Technical Service BULLETIN

RUST ON BACK DOOR GARNISH

'06 – '07 4Runner

BODY
B0010-07

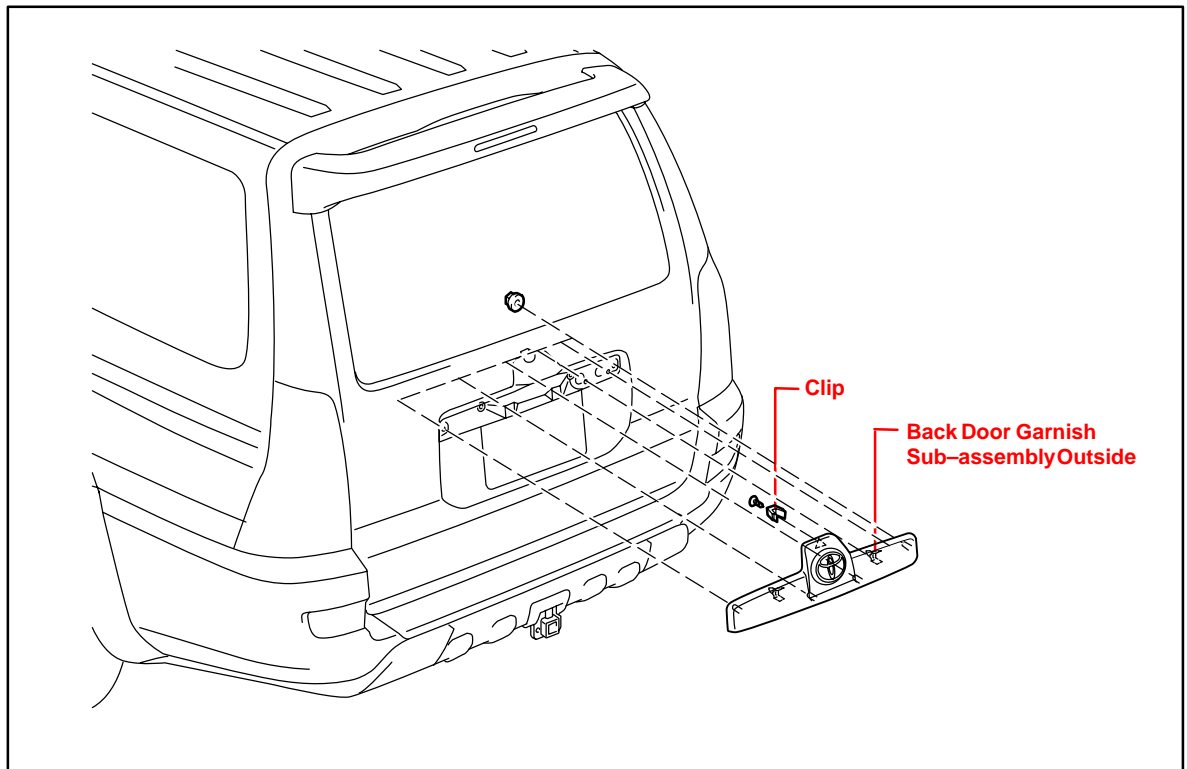
2. Remove back door service hole cover LH.
 - A. Remove the 6 nuts.
 - B. Disengage the 2 clips by pulling the garnish, and remove the garnish.
3. Replace the back door outside garnish sub-assembly with:
 - **Without the back monitor:** P/N 76801-35461
 - **With the back monitor:** P/N 76801-35471

Due to the varying degree of stain that can develop, some vehicles may need to be repainted (or stain will need to be cleaned).
